Product Change Notice (PCN)

PCN Number: PCN-0451184R-01

Product(s) Affected: PJ-050A

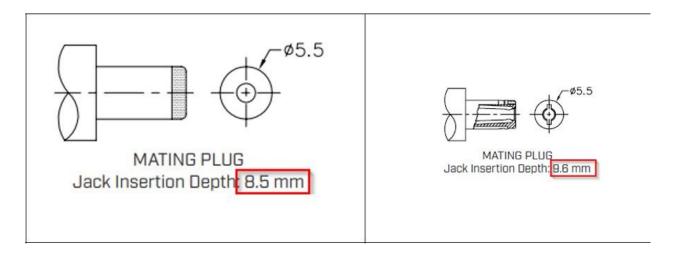
Description of Change: Mechanical, electrical, and material changes as shown below:

PREVIOUS CUI DEVICES DEFAIL (IMAGE

NEW CUI DEVICES DEFAIL (IMAGE

MATERIAL	PLATING
center pin	copper	nickel
terminal 1	brass	tin
terminal 2	copper alloy	tin
terminal 3	brass	tin
plastic	PBT

MATERIAL	PLATING/COLOR	
copper alloy(H65)	nickel	
C2680 t=0.35 mm	nickel-silver	
C5210 t=0.25 mm	nickel-silver	
C2680 t=0.30 mm	nickel-silver	
PA9T (UL94V-0)	black	
PA9T (UL94V-0)	black	
	copper alloy(H65) C2680 t=0.35 mm C5210 t=0.25 mm C2680 t=0.30 mm PA9T (UL94V-0)
